**Appendix 1: Wiltshire Housing Site Allocations Plan (WHSAP)**  
**Consolidated Schedule of Recommended Main Modifications (December 2019)**

# Inset Map Amendments

## H2.12: East of Farrells Field, Yatton Keynell

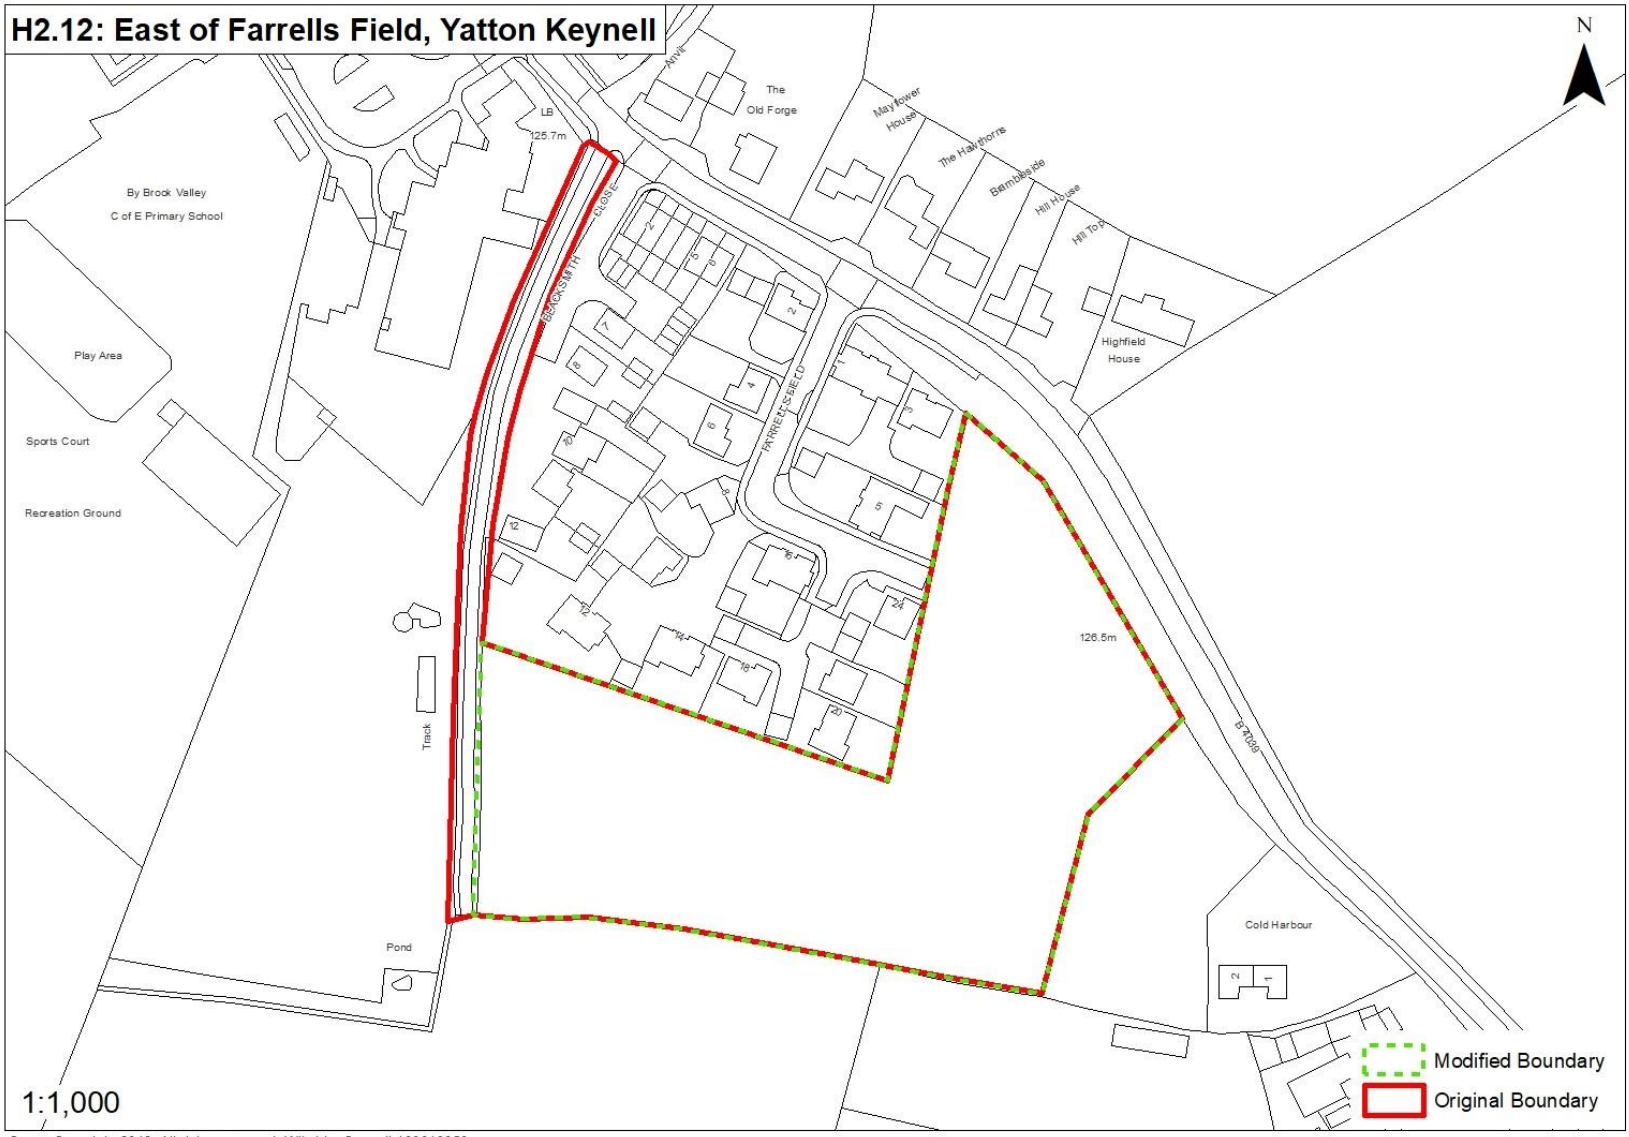
MM88	Figure 5.16	PC 88	Amend Figure 5.16 (see end of schedule – Map ‘H2.12: East of Farrells Field, Yatton Keynell’)
MM89	Housing Allocation H2.13	PC 92	Delete section titled ‘Malmesbury Community Area Remainder’ and ‘H2.13 Ridgeway Farm, Crudwell’.  Delete Figure 5.17; delete paragraphs 5.111 to 5.114.  Re-number subsequent paragraphs.
MM90	Insert new policy	FMM 49	<p>Insert new policy for H2.13 as follows:</p> <p><b><u>Land at Court Orchard/Cassways, as identified on the Policies Map, is allocated for development comprising of the following elements:</u></b></p> <ul style="list-style-type: none"> <li>• <b><u>approximately 35 dwellings;</u></b></li> <li>• <b><u>vehicular access from B3098; and</u></b></li> <li>• <b><u>improvements to cycling and walking routes through the site to link into the existing network including BRAT24 and BRAT25.</u></b></li> </ul> <p><b><u>Development will be subject to the following requirements:</u></b></p> <ul style="list-style-type: none"> <li>• <b><u>development will be informed by an ecological assessment detailing suitable mitigation measures to ensure the safeguarding of protected species and habitats of importance for biodiversity;</u></b></li> <li>• <b><u>retention and enhancement of trees and hedgerows on the site boundaries as part of wider landscaping and green infrastructure requirements. Development will be expected to take particular care to ensure that a suitable boundary with the open countryside is provided that protects or enhances landscape quality and the setting of the edge of the settlement;</u></b></li> <li>• <b><u>a Flood Risk Assessment (incorporating an assessment of the predicted effects of climate change) and comprehensive drainage strategy to inform design and layout of the site so that surface water is controlled and does not exacerbate flooding off site; and</u></b></li> <li>• <b><u>sensitive design and layout, which ensures the significance of heritage assets and their settings are not subject to unacceptable harm. This shall be informed by appropriate heritage and archaeological assessments.</u></b></li> </ul> <p><b><u>Proposals for development of the site will be informed by, and take account of, all policy requirements and opportunities in design and layout and delivered as a whole to achieve a comprehensive development that ensures the timely and coordinated provision of necessary infrastructure, services, facilities and open space.</u></b></p>

### H3.4: Land at Rowbarrow, Salisbury

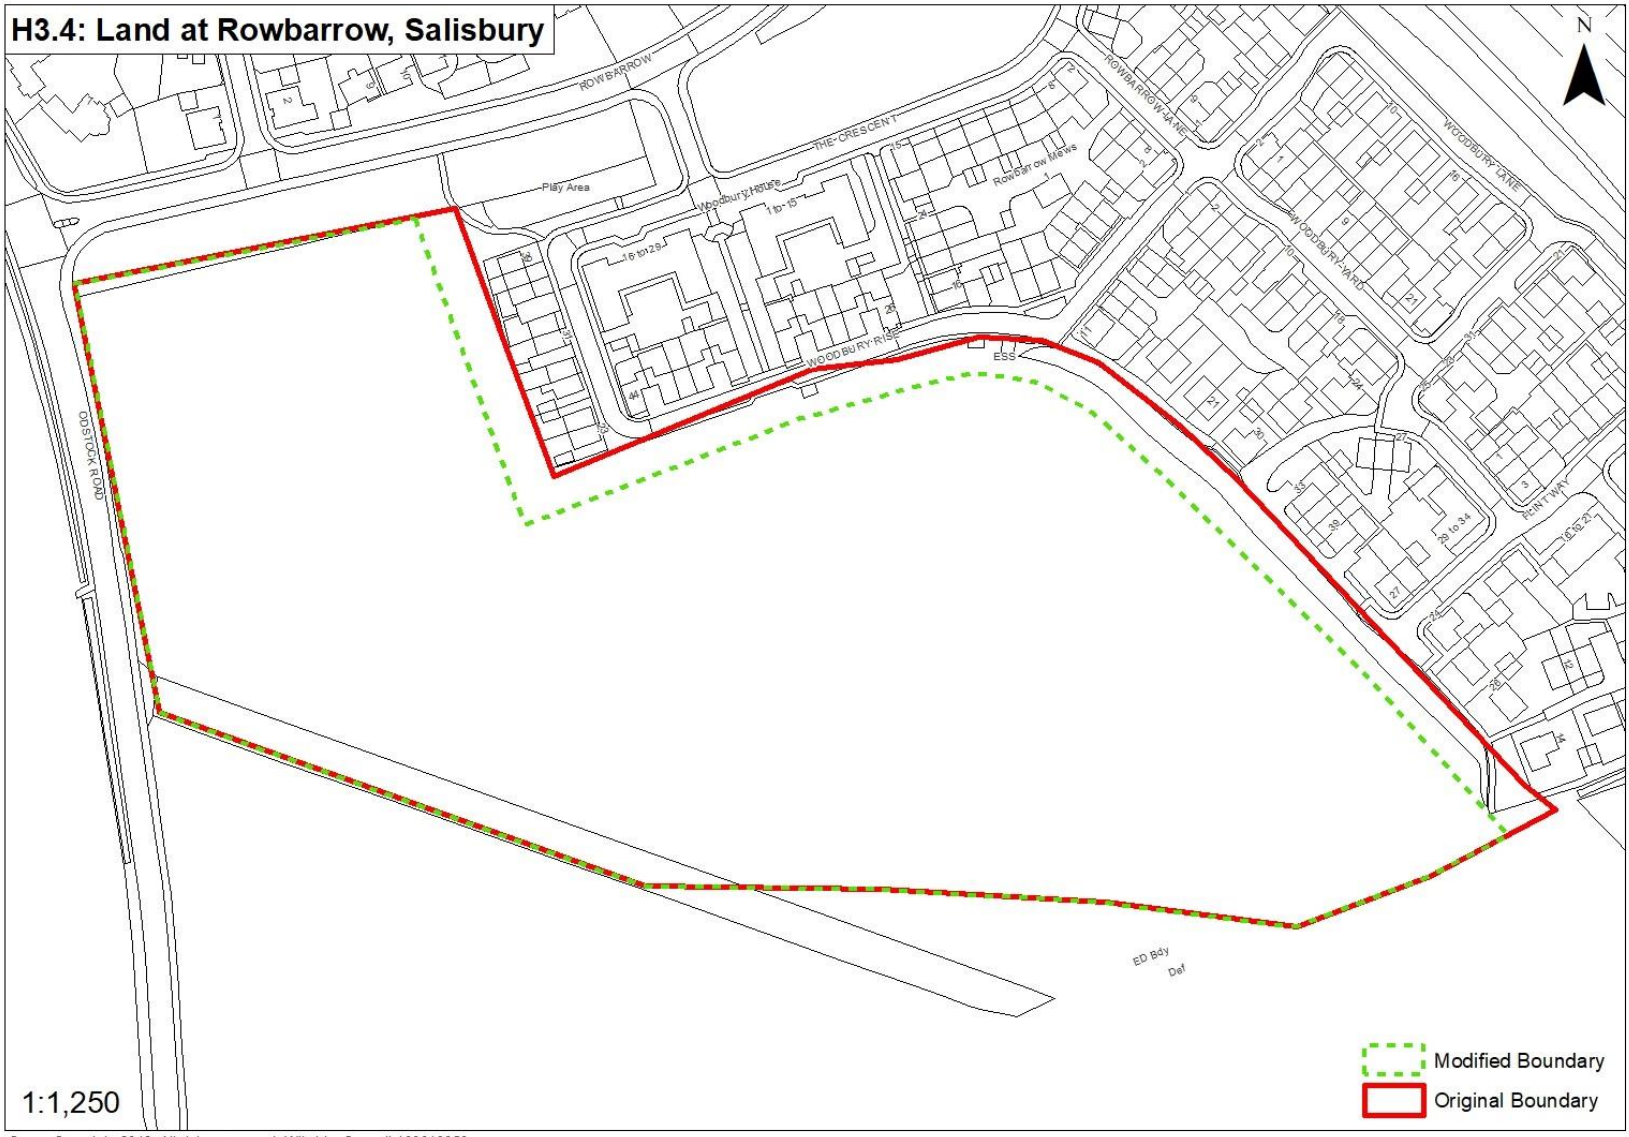
MM116	Figure 5.22	PC 108	Amend Figure 5.22 (see end of Schedule - Map 'H3.4: Land at Rowbarrow, Salisbury')
MM117	Insert new site allocation and new policy after paragraph 5.149	FMM 68 and PC111	<p>After paragraph 5.149 add in new site allocation, as set out below:</p> <p>Insert new heading, <u>H3.5 The Yard, Hampton Park, Salisbury</u></p> <p>Insert new Policy H3.5 as follows:</p> <p><b><u>Land at The Yard, Hampton Park, as identified on the Policies Map, is allocated for development comprising the following elements:</u></b></p> <ul style="list-style-type: none"> <li>• <b><u>approximately 14 dwellings; and</u></b></li> <li>• <b><u>vehicular access via the existing track onto Roman Road, with a new pedestrian and cycle access route provided through to Neal Close.</u></b></li> </ul> <p><b><u>Development will be subject to the following requirements:</u></b></p> <ul style="list-style-type: none"> <li>• <b><u>landscaping strategy and infrastructure to ensure any development appears as a natural extension to Hampton Park. Hedgerows around the site should be maintained and enhanced where possible;</u></b></li> <li>• <b><u>identification and establishment of a suitable receptor site for the translocation of slow worms in the adjacent country park, or other suitable location, to be agreed with the Council's ecologist. Development shall not take place until the receptor site has been agreed and translocation has taken place to the satisfaction of the Council's ecologist;</u></b></li> <li>• <b><u>a Precautionary Working Method for birds, including barn owl; and</u></b></li> <li>• <b><u>measures to address contamination as informed by an assessment of the sites condition.</u></b></li> </ul> <p><b><u>Proposals for development of the site will be informed by, and take account of, all policy requirements and opportunities in design and layout and delivered as a whole to achieve a comprehensive development that ensures the timely and coordinated provision of necessary infrastructure, services, facilities and open space.</u></b></p>

**H3.5: The Yard, Salisbury**

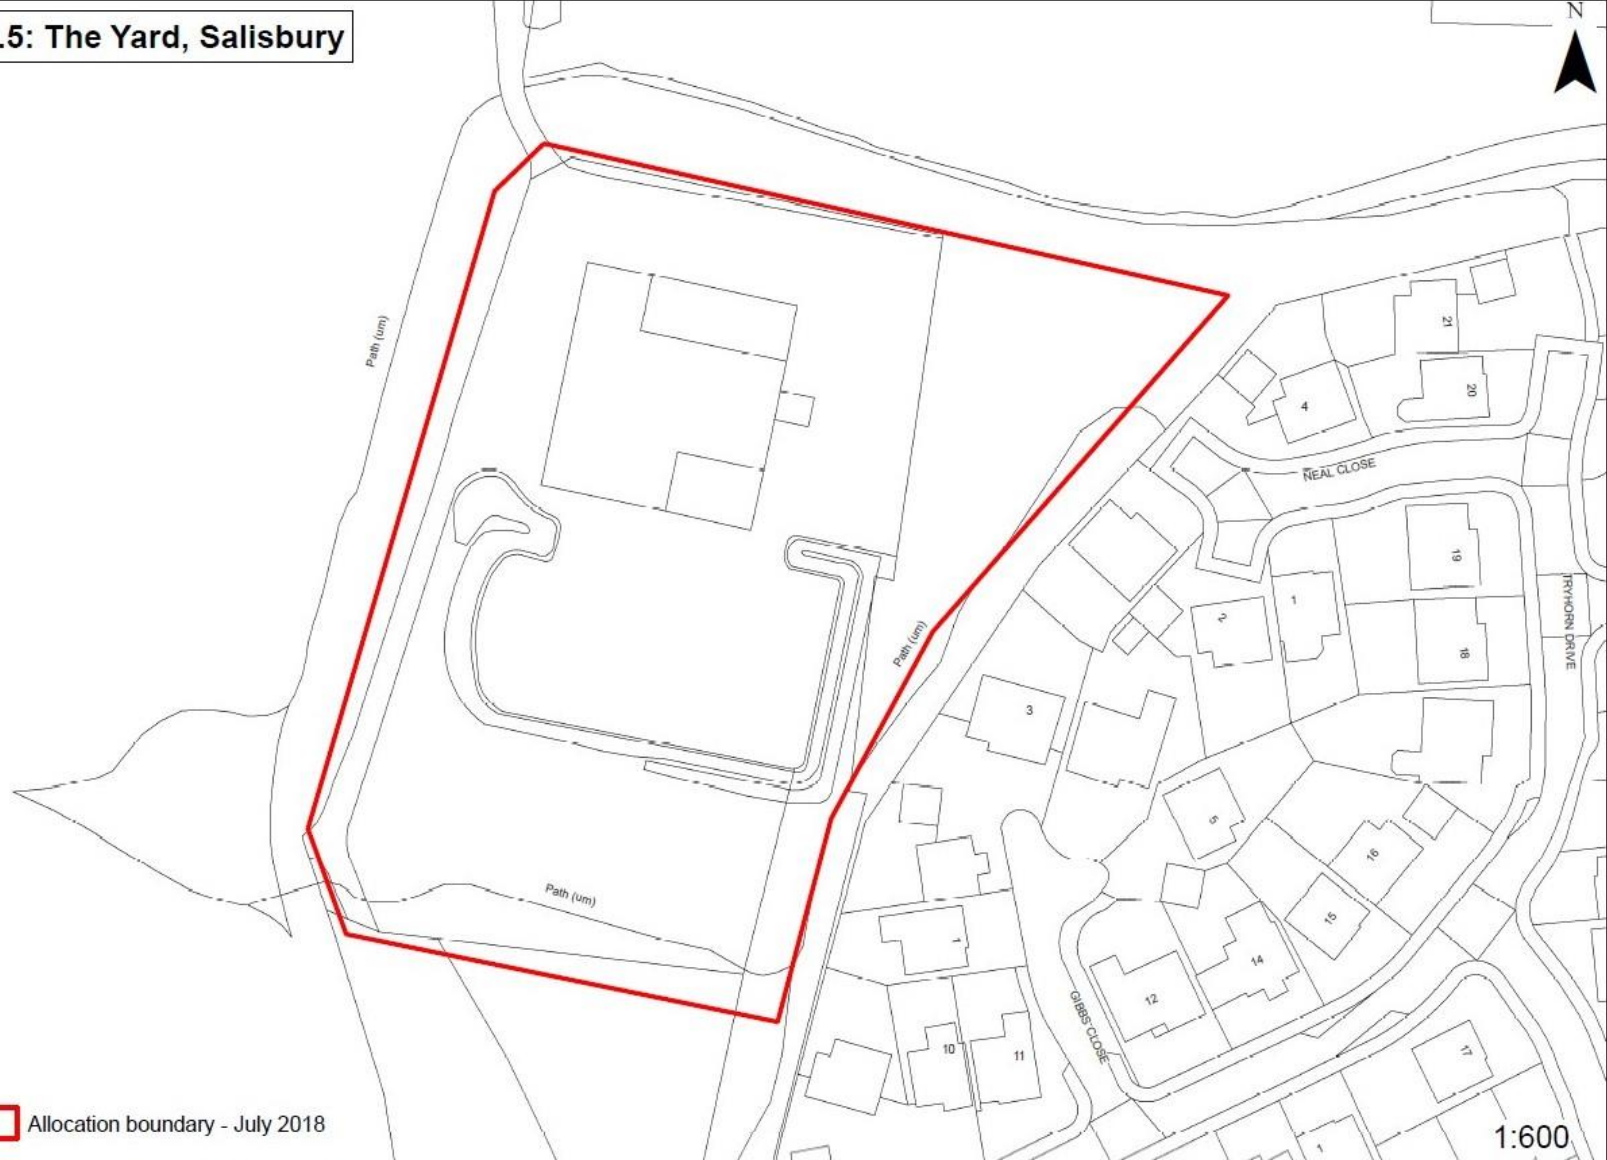
MM119	New site plan	PC 111	Insert new site figure (see end of schedule – Map 'H3.5: The Yard, Salisbury')
MM120	Paragraph 5.150	FMM 70	<p>Add additional text to end of paragraph as follows:</p> <p>...Provision of housing at Durrington would positively contribute towards the delivery of this objective by ensuring the viability of existing services and creating demand for an improved local offer. <u>Developers of the allocated sites will be expected to contribute financially towards capacity improvements in local schools and health care provision in accordance with core policies of the Wiltshire Core Strategy.</u></p>
MM121	Add new paragraph after Paragraph 5.152	PC 113	<p>Add new paragraph after Paragraph 5.152 to read:</p> <p><u>Development could contribute cumulatively towards adverse impacts on the qualifying features of the River Avon SAC through increased phosphate loading and habitat loss/damage. As such, a Nutrient Management Plan seeks to avoid the likelihood of adverse effects. Nonetheless, impacts are kept under review and this situation may change. For an interim period, developments within the River Avon SAC catchment should be phosphate neutral, which will be defined in a Memorandum of Understanding with Natural England and Environment Agency. Measures will therefore need to be in place to ensure that developments do not contribute to a net increase in phosphates for the River Avon SAC. Housing developers might consider how schemes can offset the additional phosphate loading resulting from new</u></p>

### H3.5: Clover Lane, Durrington

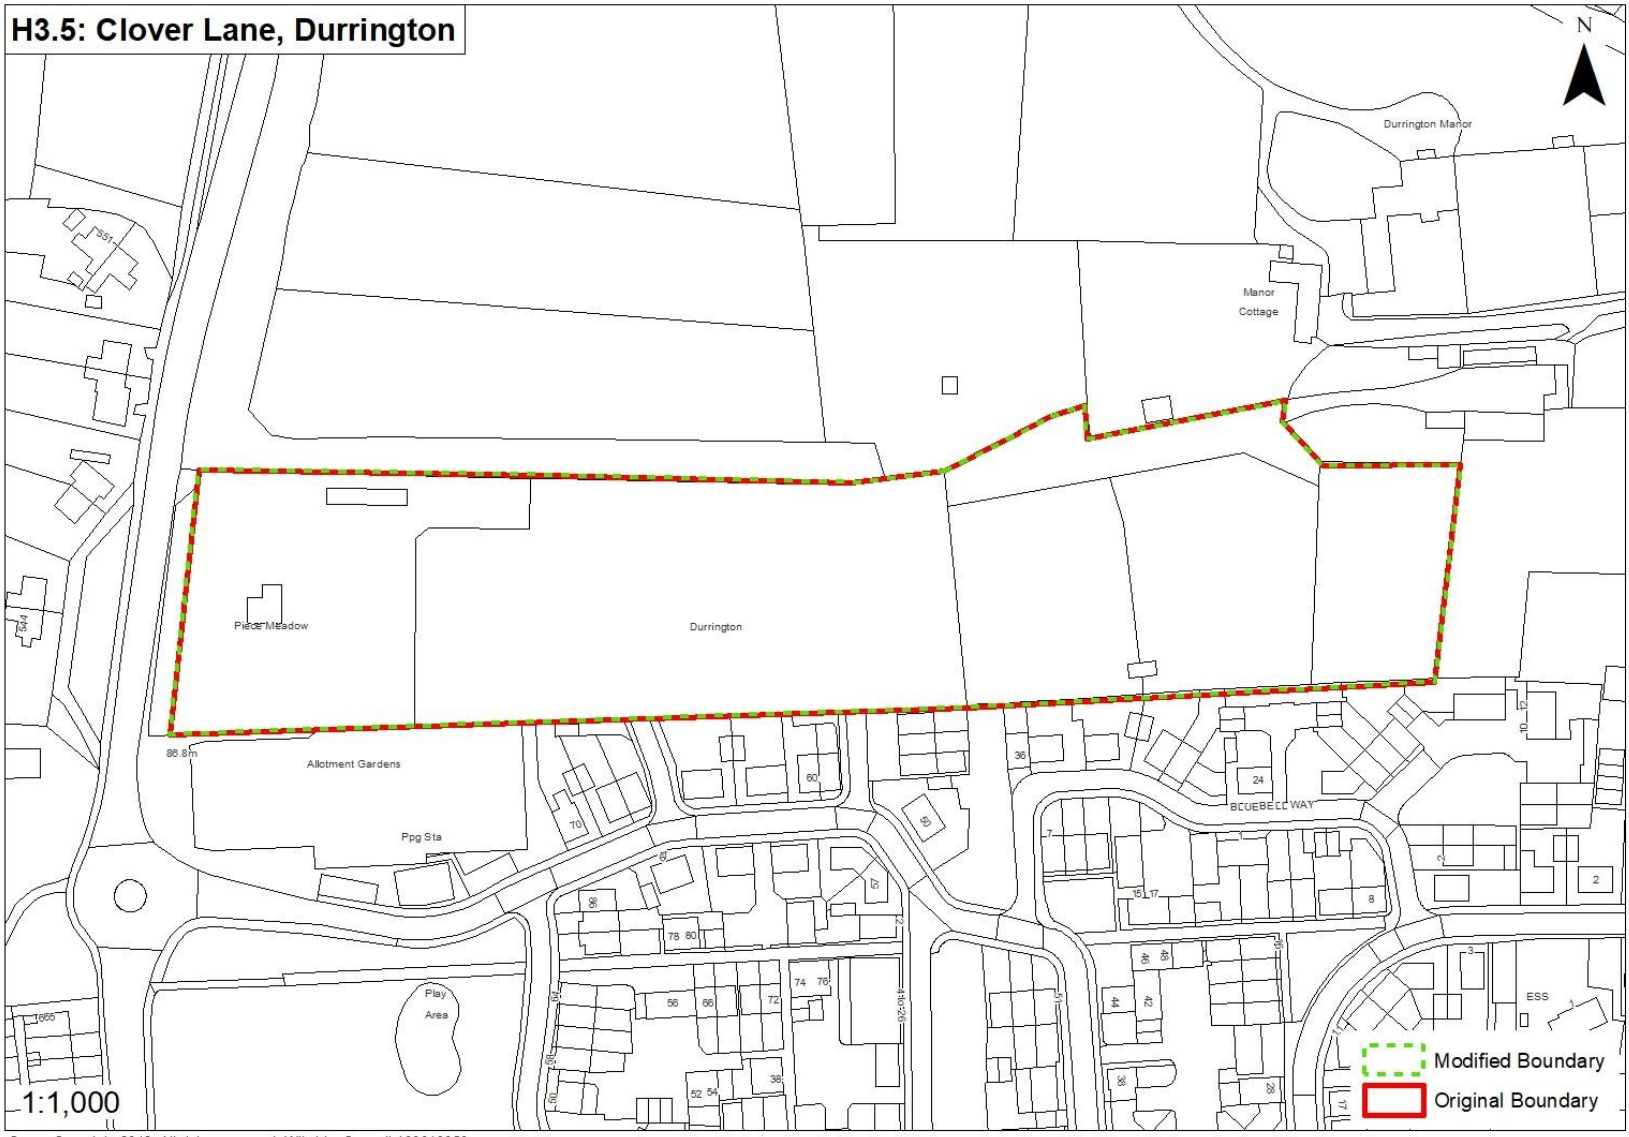
MM126	Figure 5.23	PC 114	Amend Figure 5.23 (see end of schedule – Map 'H3.5: Clover Lane, Durrington')
MM127	Insert new policy	FMM 75	Insert new policy as follows:
